Assessment Officer Report

PA2302374, Queen Victoria
Market Precinct, Towers 1
and 2

Officer Assessment Report
Development Approvals & Design

Figure 17: Podium height of Tower 1 along William Street frontage (Source: Application)

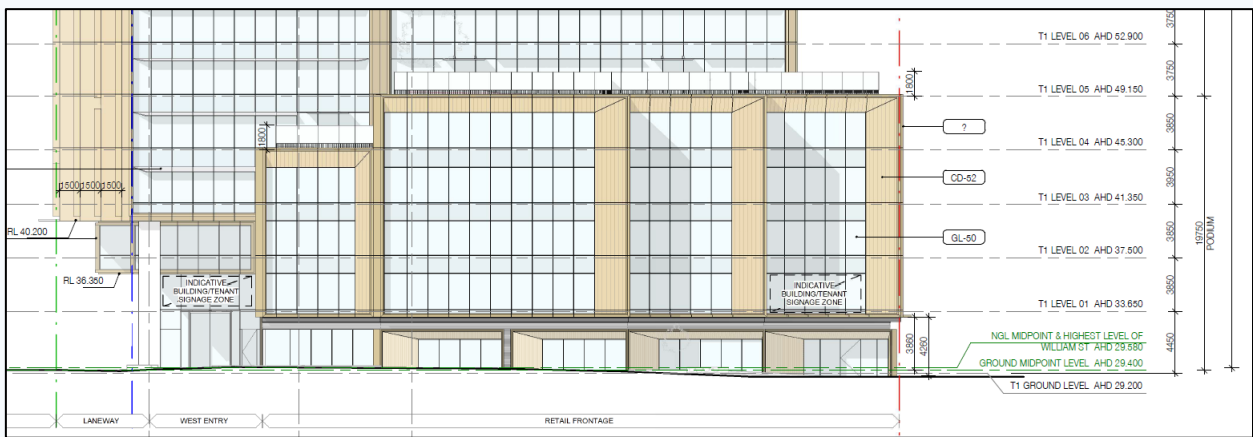
The proposed podium height of Tower 1, of 19.75 metres to William Street, is consistent with the endorsed DP.

Figure 18: Podium height of Tower 2 along Franklin Street frontage (Source: Application)

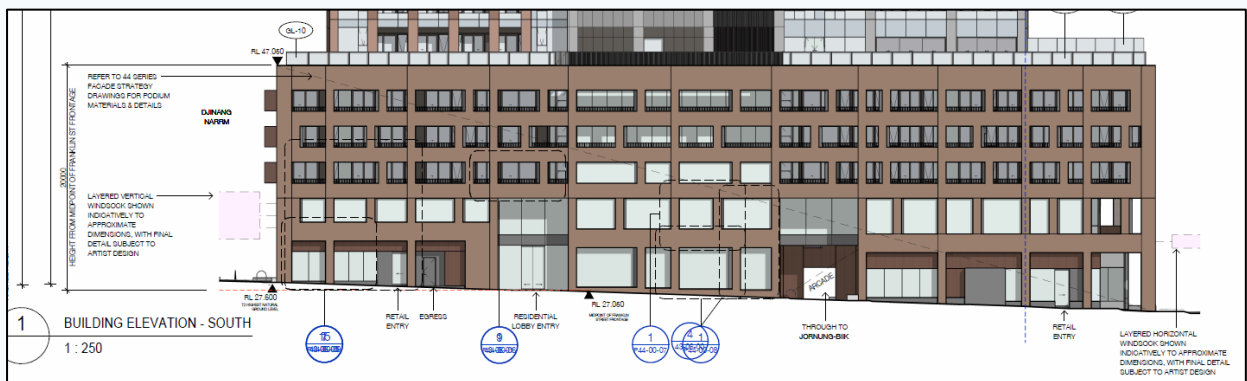
The proposed podium height of Tower 2, of 20 metres to Franklin Street, is consistent with the endorsed DP.

Figure 22: Comfort criteria as required by the DP (left) and the proposal (right)

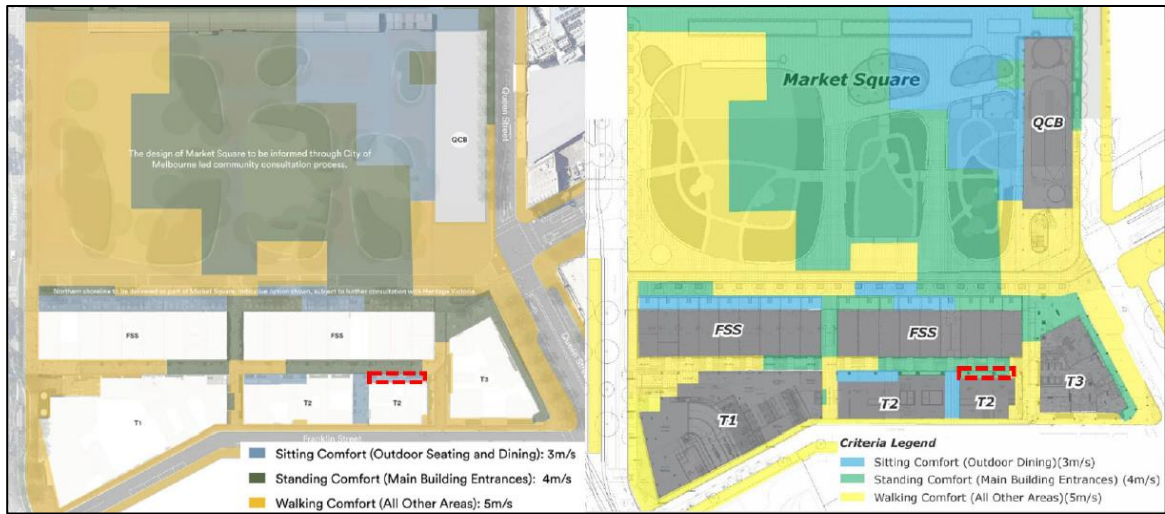
86. The report recommends a number of wind mitigation measures that are generally in accordance with those recommended in the endorsed DP.
87. The recommended wind mitigation measures include fins, wind lip, layered horizontal screens, porous vertical screens to buildings and screening to upper levels an 'X' shaped porous screen in the east-west pedestrian link. The comfort areas for sitting, standing and walking generally comply with the DP, with the exception of a small area to the north of Tower 2, identified in red below. In the context of the broader precinct, the area will achieve standing, rather than sitting comfort and this is considered acceptable, noting the challenging wind conditions in this location of the city.

- 88. A condition will be included on any permit to issue requiring the further testing to reflect any final design changes and to ensure that the proposal continues to achieve the target wind comfort and safety criteria as required by the endorsed DP.
- 89. The wind report also recommends wind mitigation measures in the public realm, outside the title boundaries for Towers 1 and 2. These include concrete bollards, planter boxes, street furniture, vegetation and screens to the tram stop on Peel Street. As such, a condition (following consultation with the applicant and the council) will also be included on any permit to requiring the owner to enter into a Section 173 Agreement to ensure all wind mitigation measures in the public realm and outside the subject site title boundaries are designed, delivered and implemented prior to occupation of the development.

Figure 28: Level 02 daylight analysis (Source: Application)

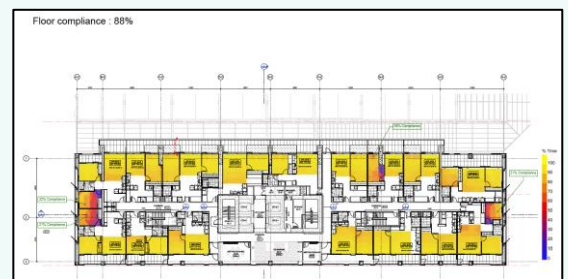
The submitted architectural plans and Development Summary demonstrate that 100% of habitable rooms enjoy direct access to daylight.

Further, a Daylight Modelling Memo prepared by WSP and dated 15 December 2023 demonstrates that the podium levels, Levels 02-04, achieve acceptable levels of daylight. Green Star requires that a minimum of 60% of the combined living room and bedroom areas receive high levels of daylight. The figure below show that the podium levels exceed this requirement. The council's ESD officer has assessed this and raised no concerns.
